SEWAGE DISPOSAL SYSTEM

HOWARD COUNTY HEALTH DEPARTMENT

SUBDIVISION Coventry Meadows LOT 14 ROAD 1460 Coventry Meadows Drive

TITLE: GRADING STUDY				
PROJECT: LOT 14 - COVENTRY MEADOWS - SECT. 2				
LOCATION: 3RD ELECTION DISTRICT HOWARD CO., MD.				
SCALE: 1"=100'	DESIGNED BY:	DRAWN BY: J.B.	CHECKED BY:	DATE: NOV, 1993
FIELD BOOK:	PAGE NO.:	JOB NO.:	DRAWING NO.:

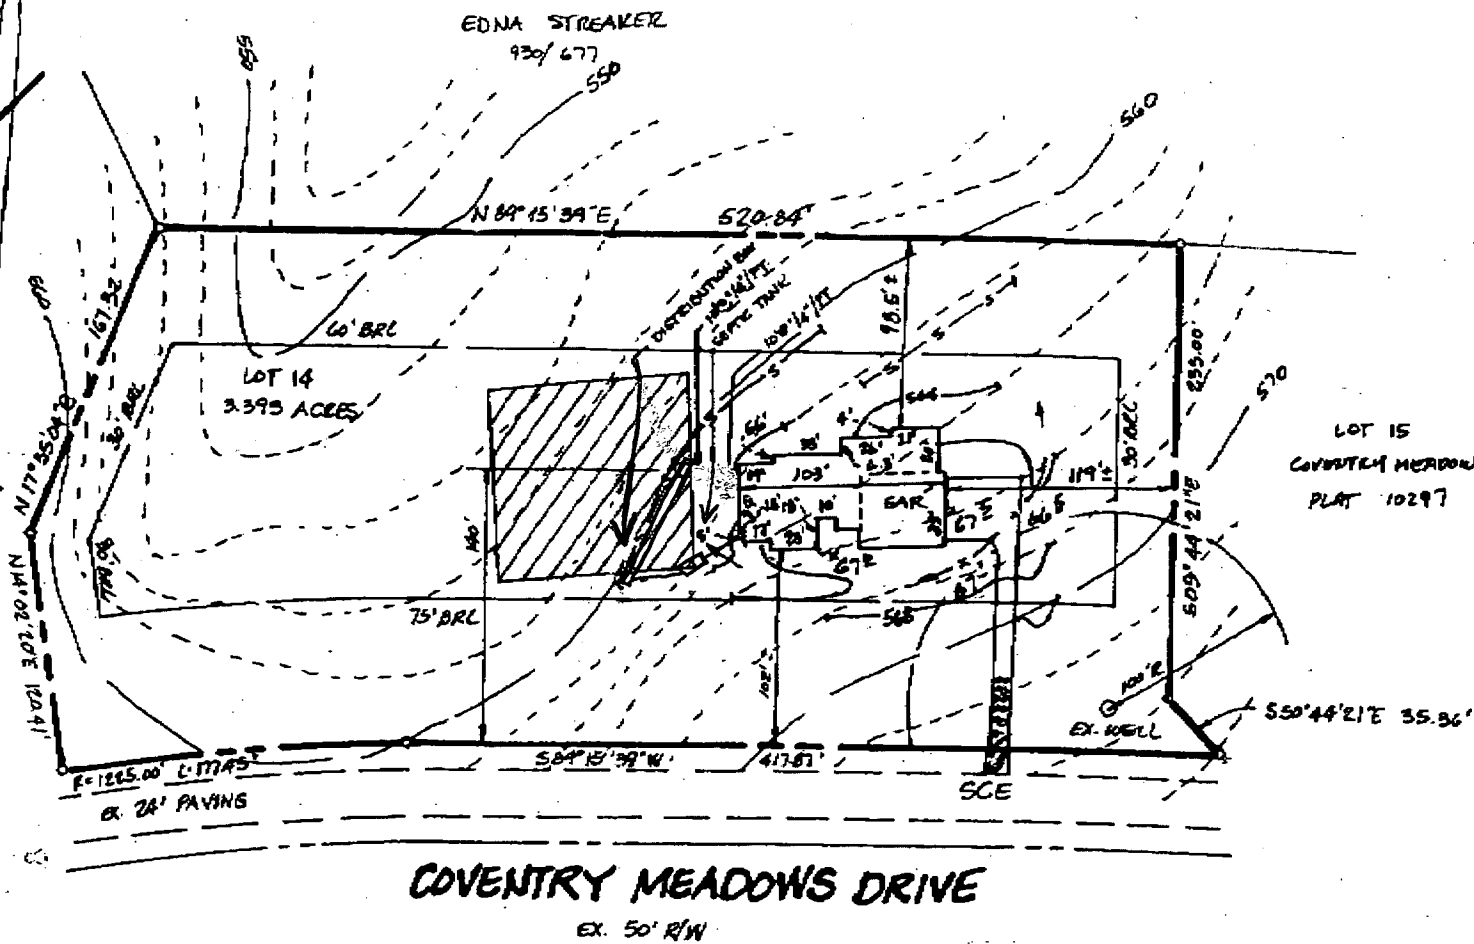
REVISED
 SITE PLAN OK
 MR 12/3/93

#46854
 REVISED
 Date: 11.12.93
 Comments: House relocated
